Cassiopea Sweaters Ltd.

27th January 2019 and 5th February 2019

Observations

Review of design report

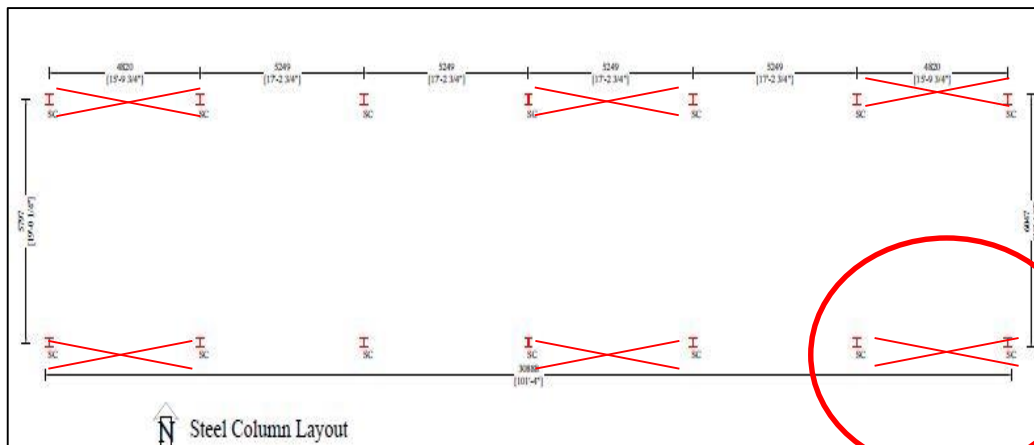
Cursory calculation indicates that column factor of safety is satisfactory considering 3 kPa live load and minimum concrete strength for stone chips aggregate.

Factor of Safety was found below normal design limit considering live load 5 kPa (mentioned in design report/live load plan) and minimum concrete strength for stone chips aggregate.

In design report and analysis model concrete strength of column is considered **33.8 MPa**. Calculation is not provided for the considered value of concrete strength. Also most of the concrete cylinder test report indicate that they were from slab.

Bracing layout

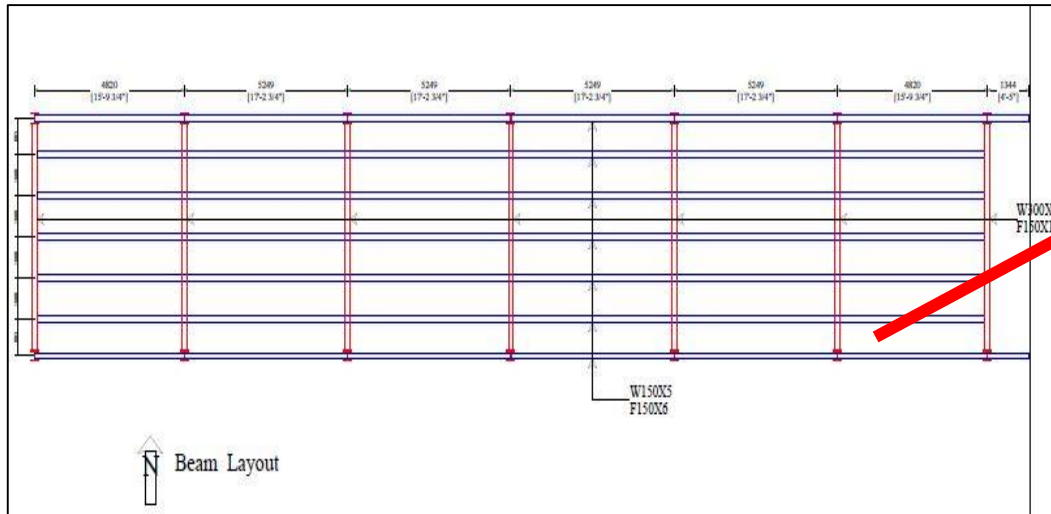
Missing bracing & lateral stability of utility shed

Missing bracing

Beam Layout

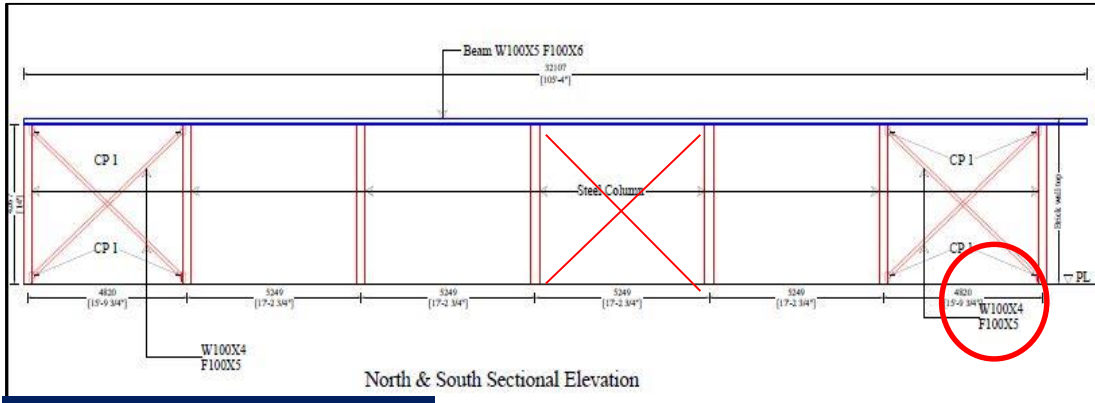
Number of beams in long direction are not matched. Six beams were observed instead of seven beams.

Bracing section

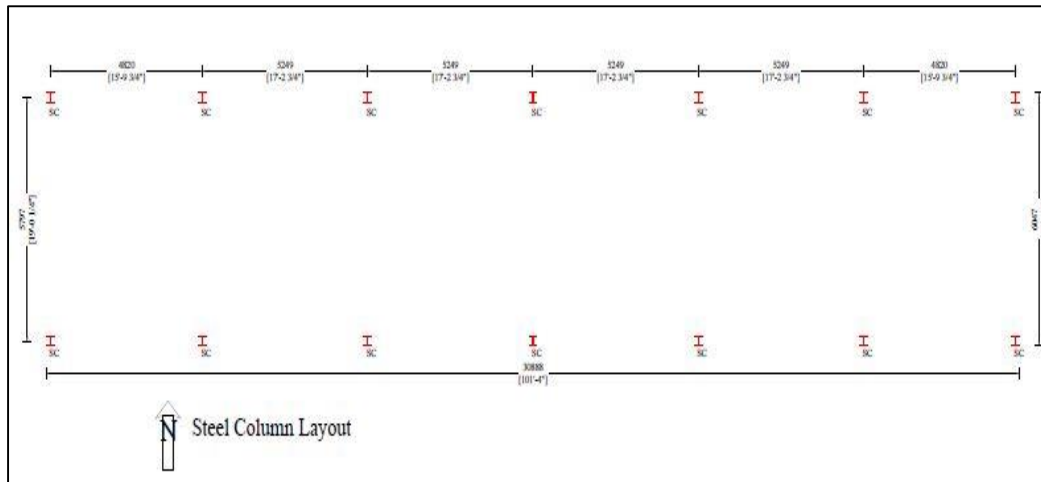
C section(150 X 75 X 5) instead of
W section(W:100 X 4 F:100X5)

Grid dimension did not match with as-built condition

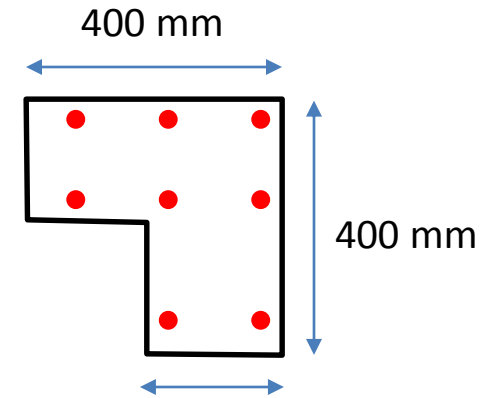
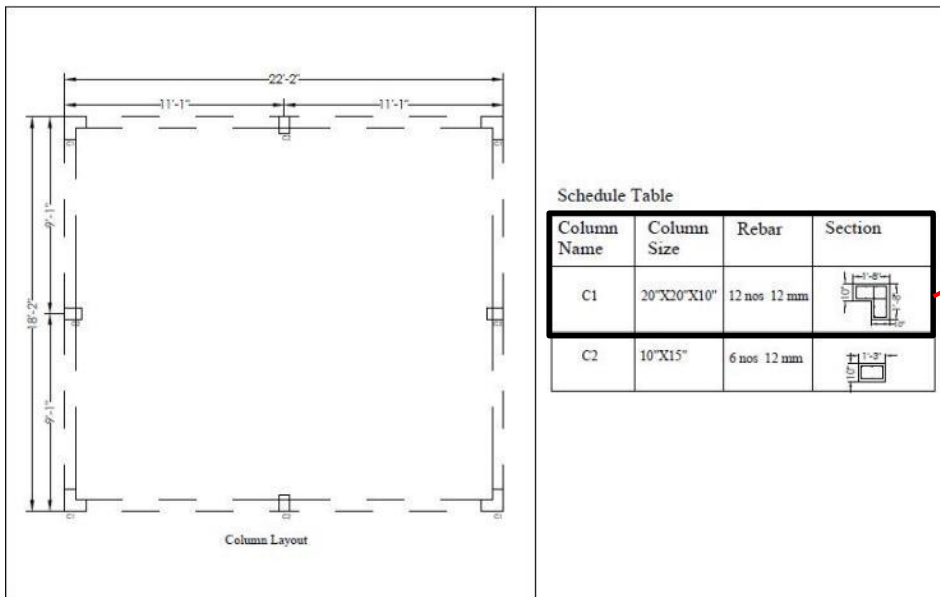
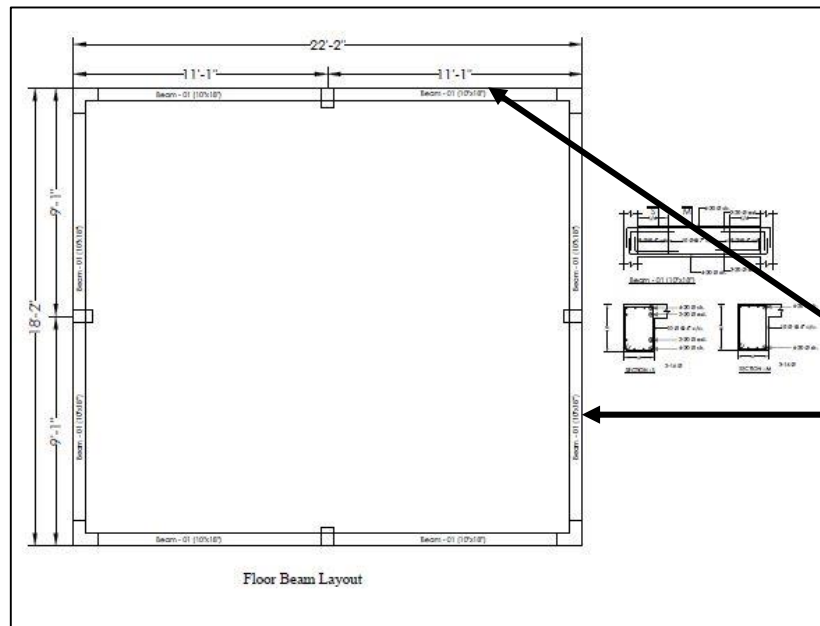
Column size was measured 400mm instead of 450 mm. Also number of rebar counted 10 instead of 12.

Presence of this beams was not indicative.
